Access Compliance Report

Public Rights-of-Way

(Curb Ramps)

Intersection ID: 10028229	Main Street: HEATHSTEAD_PL	Cross Street: N/A	Location: NE
ADA ID: 6192FD9B8976	Ramp Type: PerpDiag	Initial Pass/Fail: Fail	Overall Compliance: No
Severity Score: 72.5			
Codes/Mitigation Info/Possible Solution		Field Measurements/Component Compliance

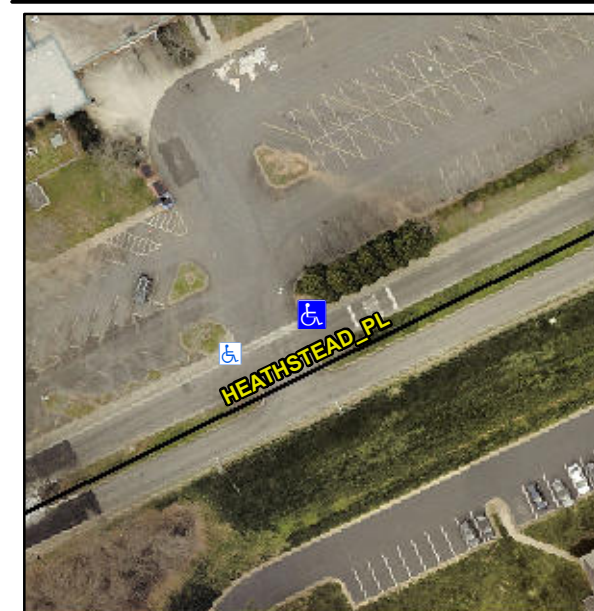
Not Found, R304.5.1, R304.2.2, R304.5.3

Compliance	Description	Data	Compliance	Description	Data
N/A	Ramp Length (in)	60.0	No	Ramp Slope (%)	8.6
No	Ramp Width (in)	26.0	No	Ramp XSlope (%)	7.8
N/A	Flare Type LT	N/A	N/A	Flare Type RT	N/A
N/A	Flare Slope LT (%)	N/A	N/A	Flare Slope RT (%)	N/A
N/A	Flare Traversable LT?	N/A	N/A	Flare Traversable RT?	N/A
N/A	Landing Length (in)	N/A	N/A	DWS Provided?	N/A
N/A	Landing Width (in)	N/A	N/A	DWS Contrast?	N/A
N/A	Landing Slope (%)	N/A	N/A	DWS Length (in)	N/A
N/A	Landing X Slope (%)	N/A	N/A	DWS Full Width?	N/A
N/A	Landing Curb? (Y/N)	N/A	N/A	DWS Offset (in)	N/A
N/A	Shared Landing?	N/A			
N/A	Gutter Ponding?	N/A	N/A	Gutter Slope (%)	N/A
N/A	Gutter Lip Ht (in)	N/A	N/A	Gutter X Slope (%)	N/A
N/A	Painted X Walk1?	No	N/A	Painted X Walk2?	No
	X Walk 1 Direction	To SW		X Walk 2 Direction	To SE
N/A	X Walk 1 Width (in)	N/A	N/A	X Walk 2 Width (in)	N/A
	X Walk 1 Slope (%)	2.0		X Walk 2 Slope (%)	6.6
	X Walk 1 X Slope (%)	7.2		X Walk 2 X Slope (%)	0.1

Remove & Replace Curb Ramp With Two New Directional Ramps or Equivalent.
